## INTRODUCTION

Since the introduction of the THM 440-T4 Transaxle in April, 1984, there have been many major engineering design changes. These changes have affected nearly every part used in the THM 440-T4. This Update Handbook will explain each change, the parts affected by the change, and any parts interchangeability problems created by the change.

### THM 440-T4 PUMP INFORMATION

Figure 86

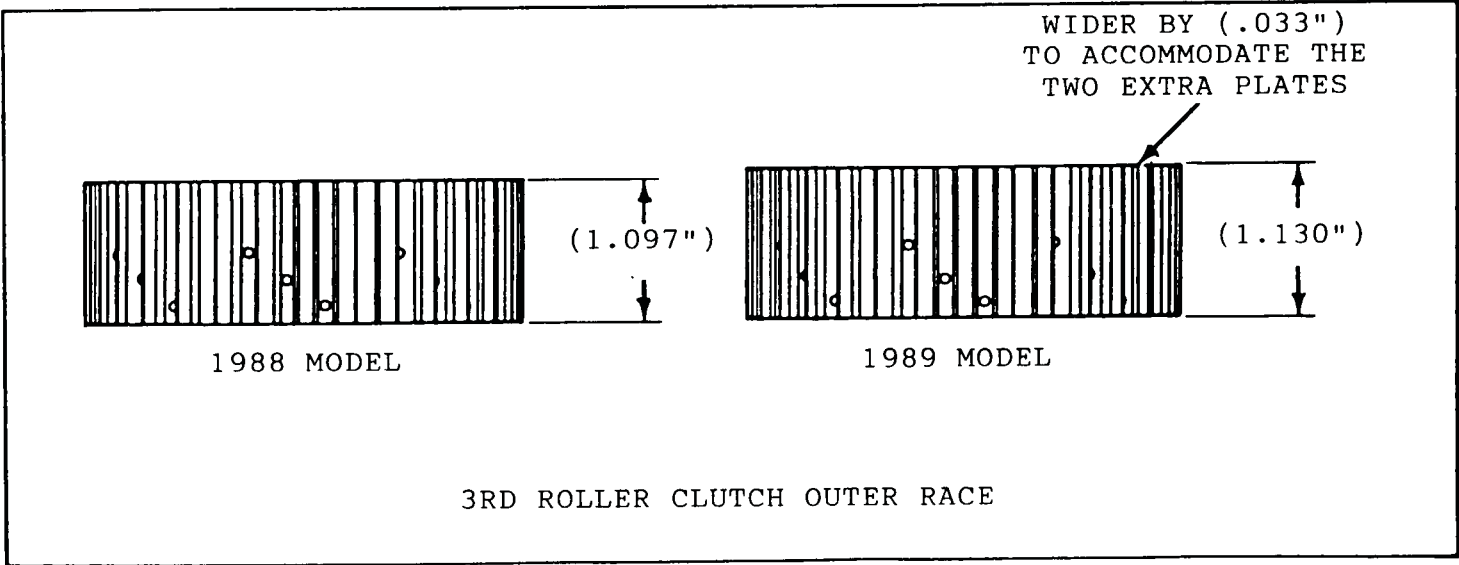
- (5) 3rd Roller Clutch Outer Race - The outer race was made wider by .033" to accomodate the two extra plates. The rollers have not changed in width (See Figure 86).

Figure 87  
87

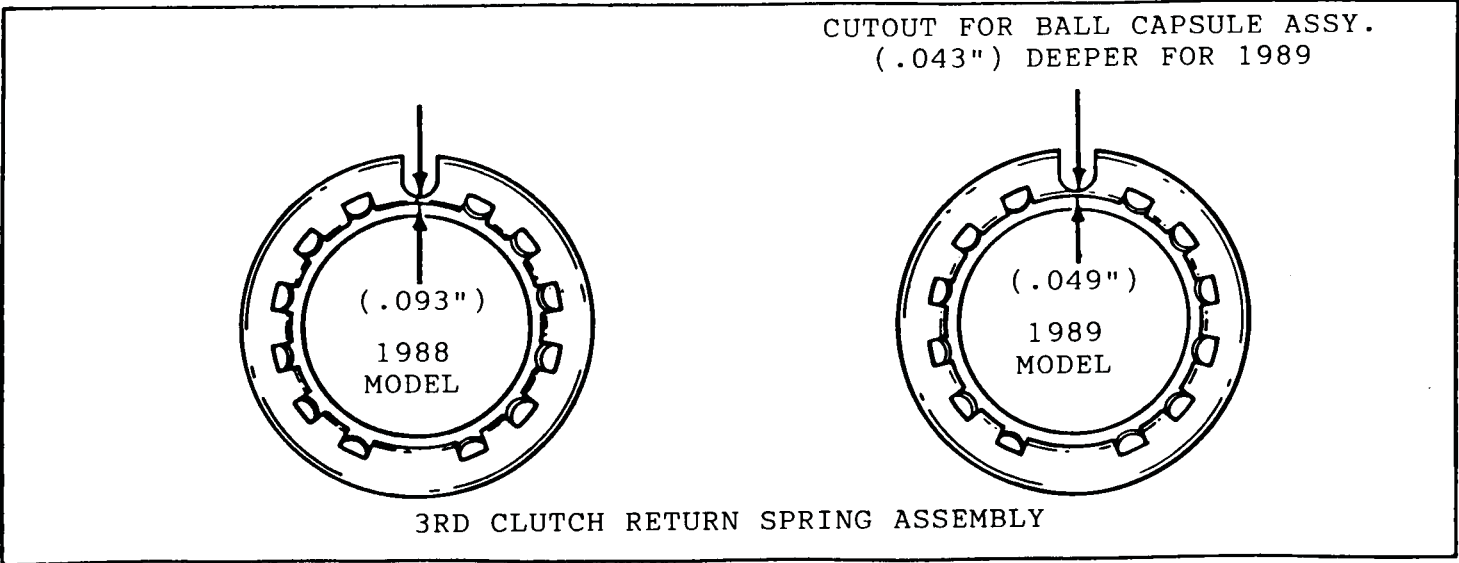
- (6) 3rd Clutch Return Spring Assembly - The cutout in the retainer is .045" deeper to accomodate the relocated ball capsule in the new (Smaller Diameter) 3rd clutch piston and seal Assy. (See Figure 87).

Figure 88  
89

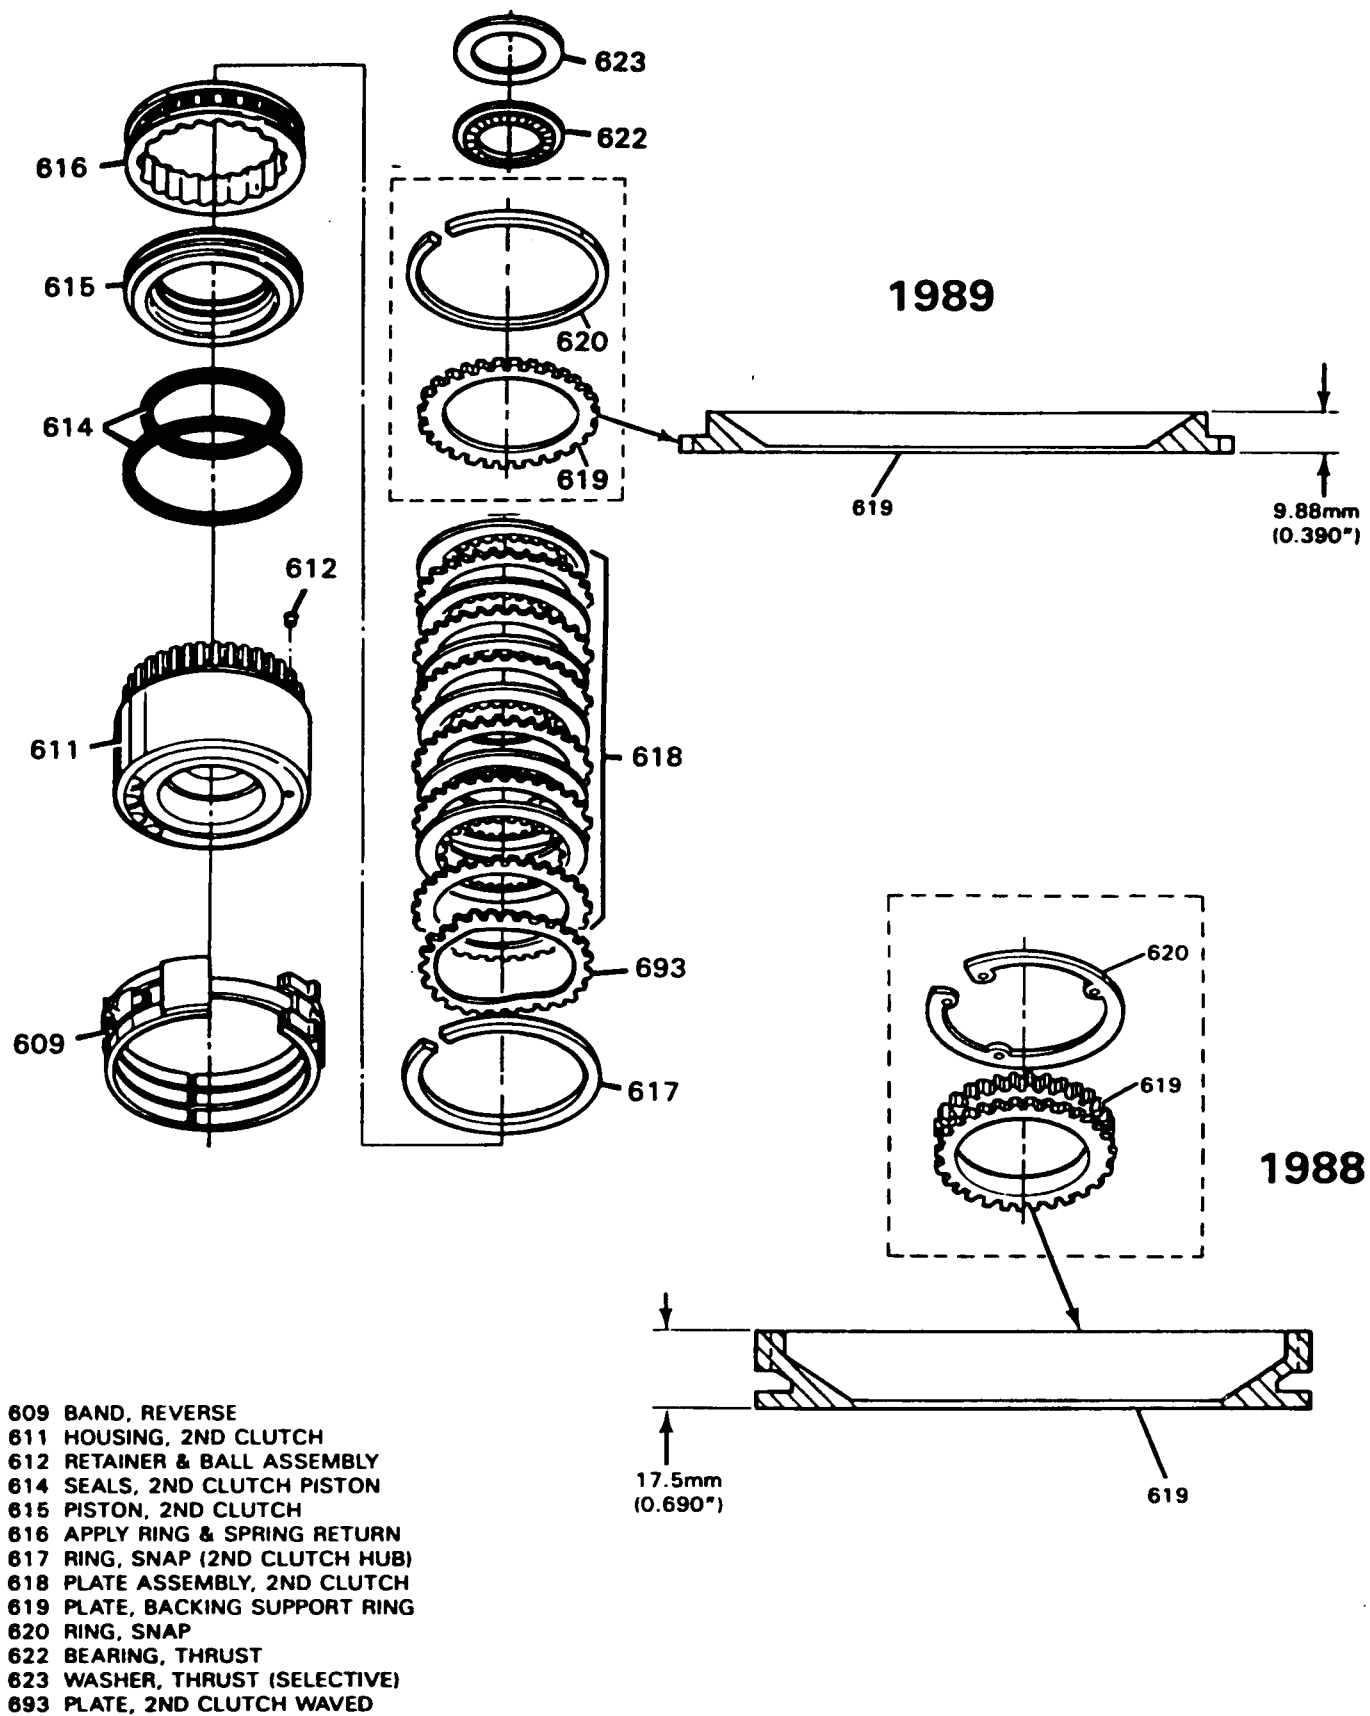
CHANGE: 2nd Clutch Backing Plate was redesigned (See Figure 88).

- (1) 2nd Clutch Backing Plate - "Windows" in backing plate are eliminated which makes the backing plate less prone to warpage. Also notice (See Figure 88) that the support ring has been eliminated from the backing plate and is no longer used, because "Engine Torque Management" was added as an ECM function. This was one of the reasons for the addition of the 2nd clutch switch in 1988.
- (2) 2nd Clutch Backing Plate Snap Ring - The new snap ring is only half as wide as the previous models and must be used with the third design backing plate.

Figure 89

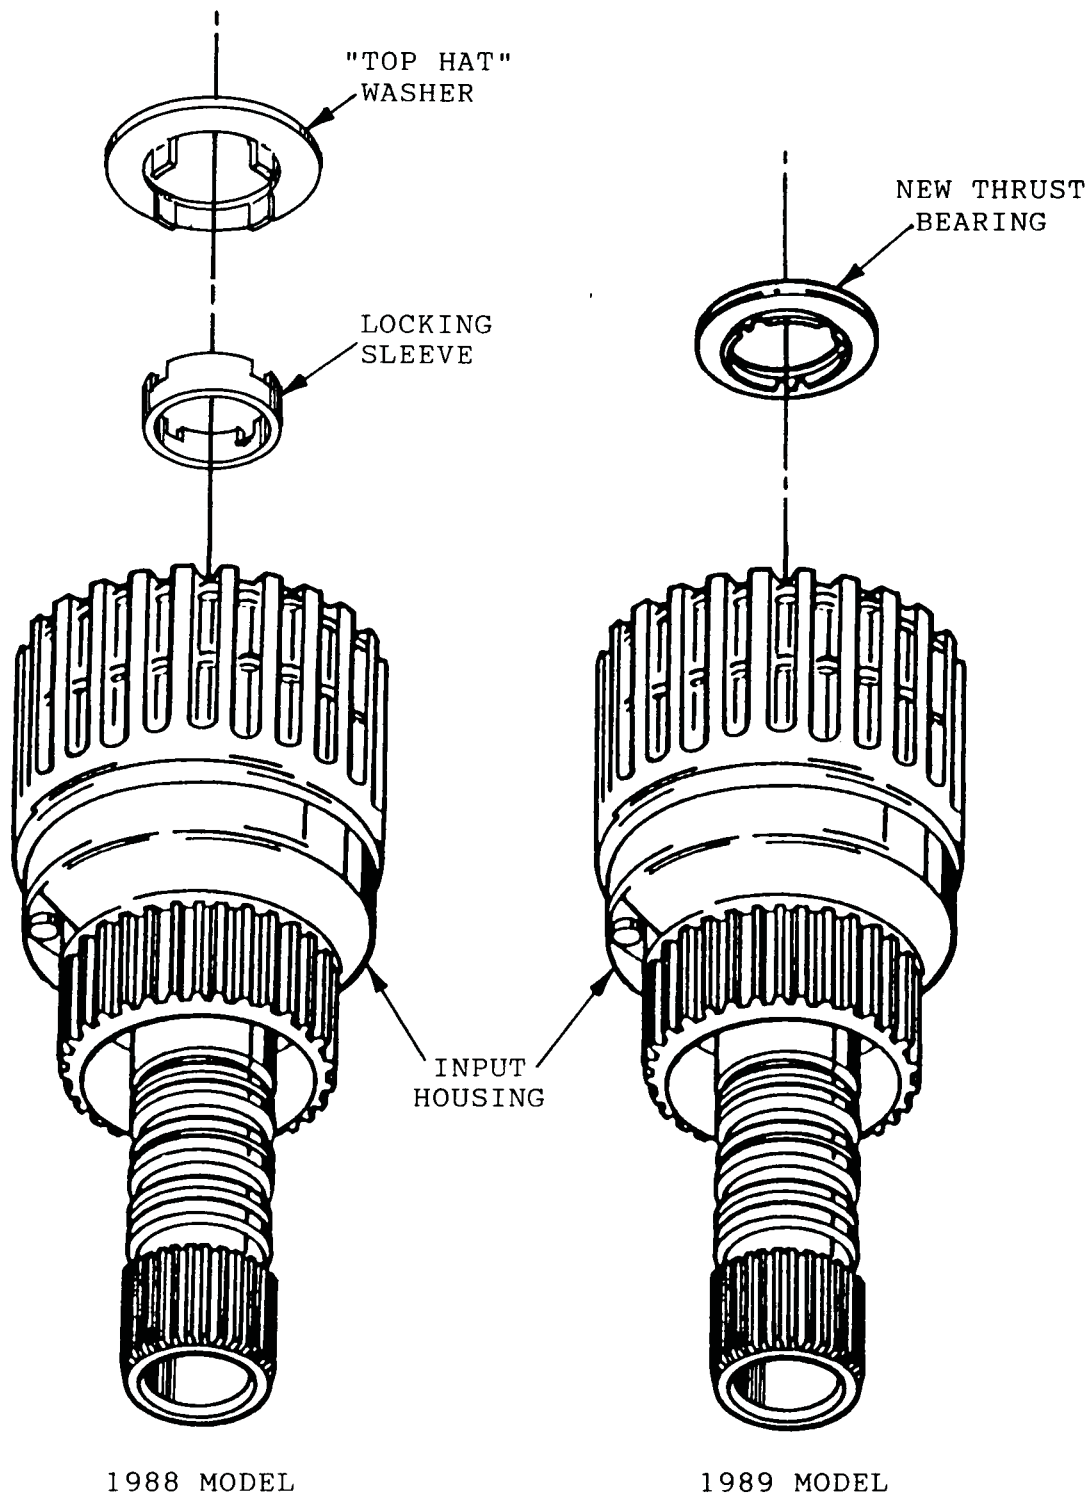
**CHANGE:** A new Thrust Bearing Assembly replaces the "Top Hat" Thrust Washer and Lock Up Sleeve in the input housing. (See Figure 89). The new bearing and related parts went into production on all 1989 models on November 28, 1988 (Julian Date 333).

Figure 91

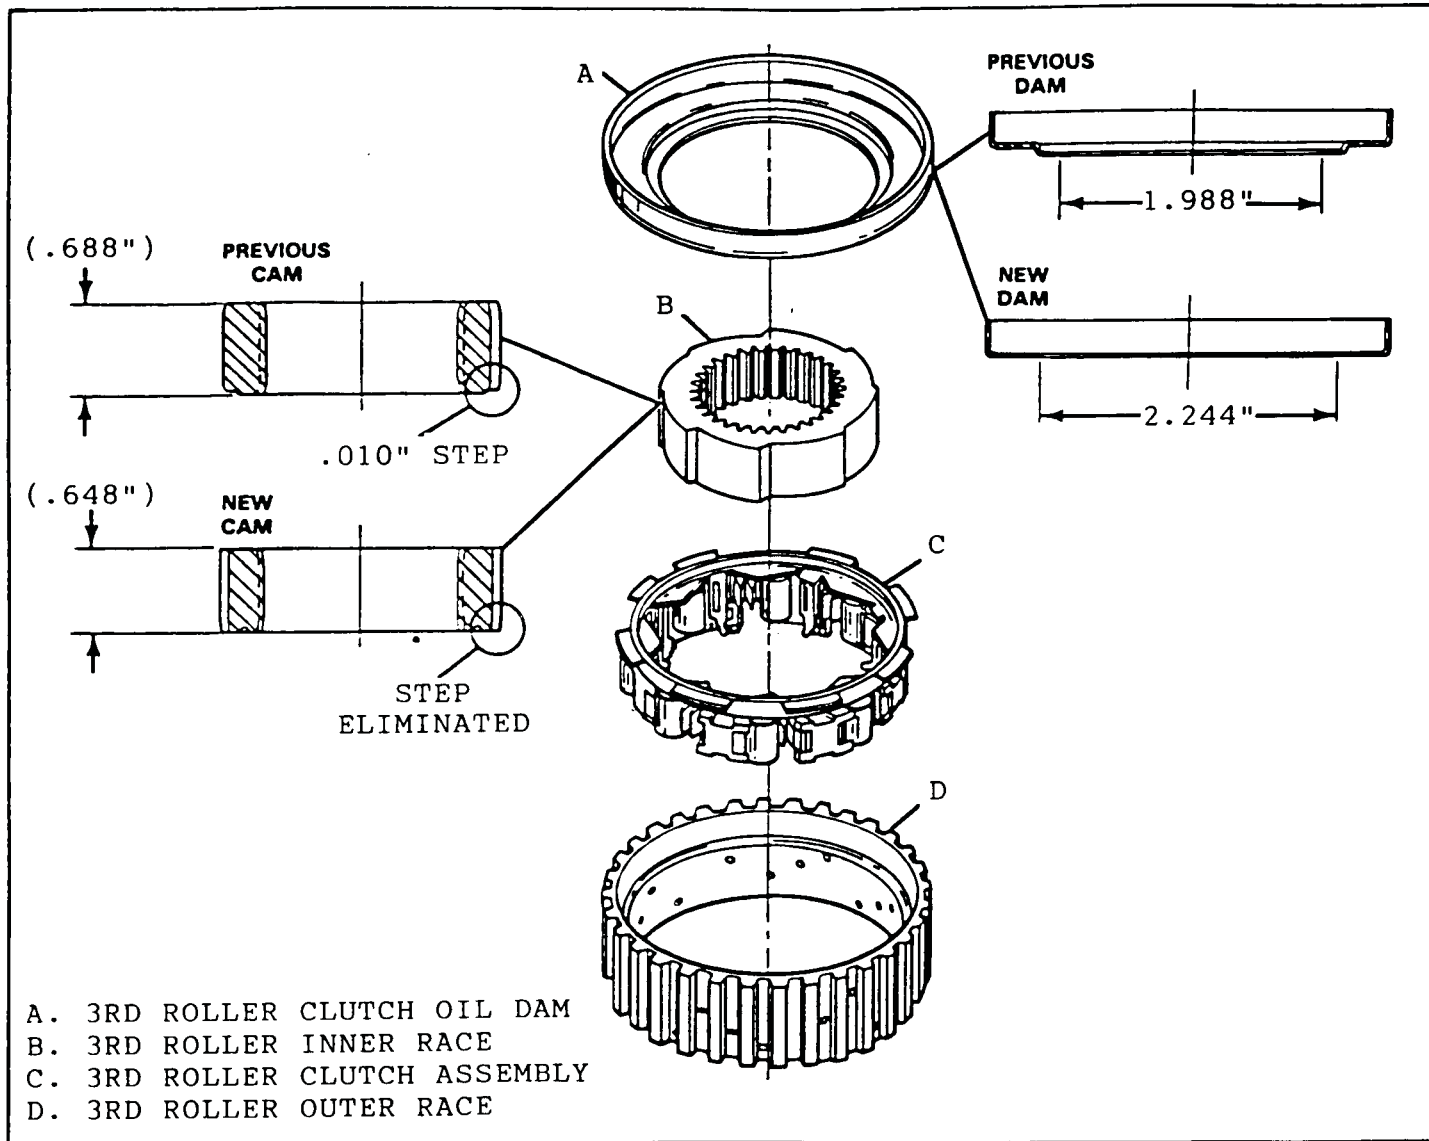
- (1) Input Housing - Surface on the input housing where the new bearing assembly rides, has been reduced by .035" to accommodate the increased thickness of the new bearing (See Figure 90).
- (2) "Top Hat" Thrust Washer - Eliminated (See Figure 90).
- (3) Lock Up Sleeve - The lock up sleeve is no longer needed and has been eliminated (See Figure 90).
- (4) 3rd Roller Clutch Lube Dam - The inside diameter has been increased by .256" to accommodate the larger diameter new bearing, and the lip on the lube dam eliminated for increased lube flow to the 3rd roller assembly (See Figure 91).
- (5) 3rd Roller Clutch Inner Race - Has been machined .040" thinner to accommodate the increased thickness of the new bearing assembly (See Figure 91).

Figure 92

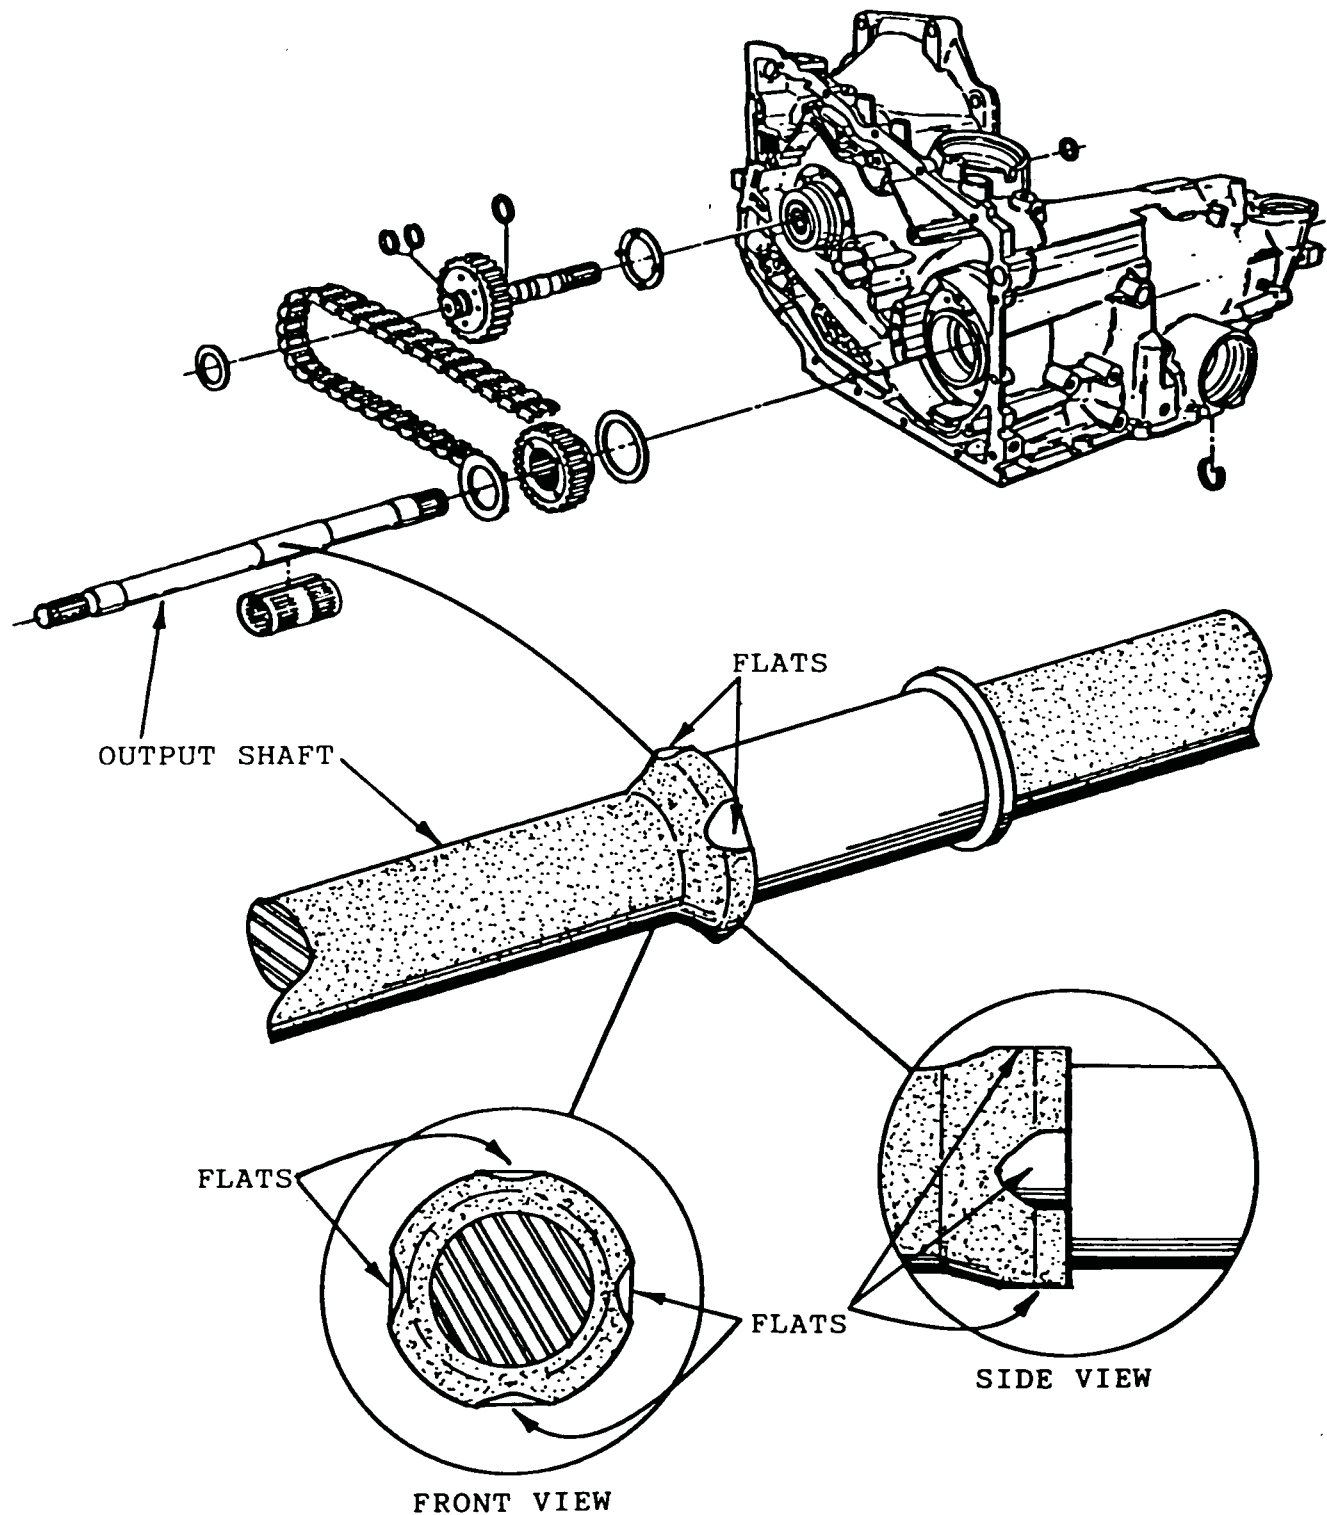
- COMPLAINT: Repeated failure of the 3rd Roller Clutch and/or the Input Sprag Assembly.
- CAUSE: Lack of lube oil to 3rd Roller Clutch and Input Sprag.
- CORRECTION: Modification as follows, of the parts indicated, will increase lube flow to both the 3rd Roller Clutch and the Input Sprag.

1. MODIFY OUTPUT SHAFT:  
Grind four (4) flats on the Output Shaft at the front of the bearing in the locations shown in Figure 92.
  2. MODIFY OUTPUT SHAFT BEARING:  
Remove individual needle bearings as shown in Figure 93 in three equally spaced locations around the bearing, to provide three "Troughs" for additional lube oil to flow. Removing the needles does not impair the durability of the bearing assembly.

Figure 93

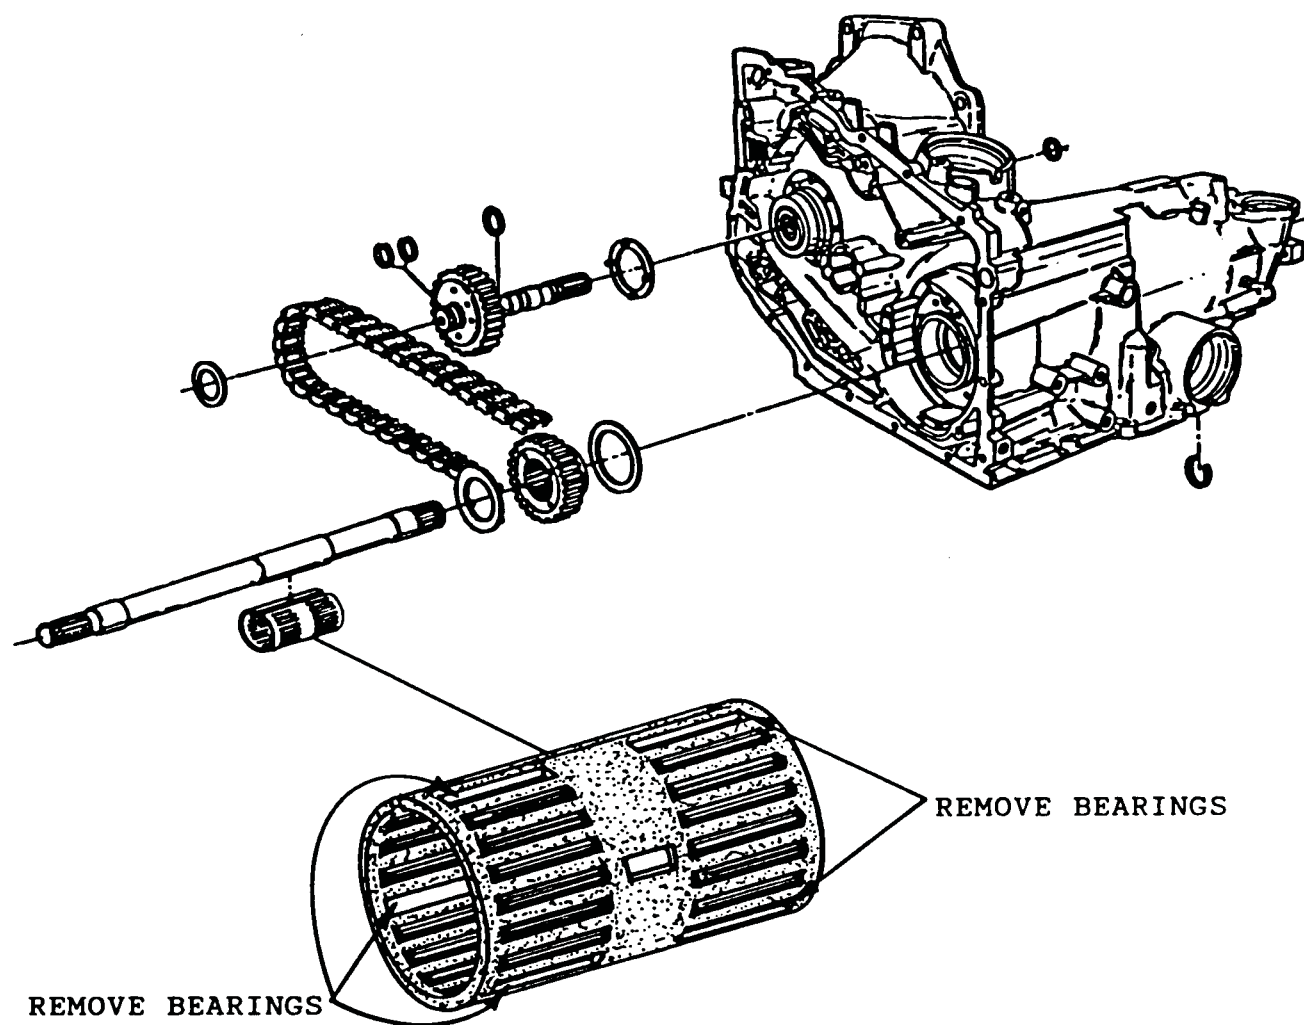
REMOVE INDIVIDUAL NEEDLE BEARINGS IN THREE EQUALLY SPACED LOCATIONS AROUND THE BEARING TO PROVIDE THREE "TROUGH" FOR ADDITIONAL LUBE OIL TO FLOW.
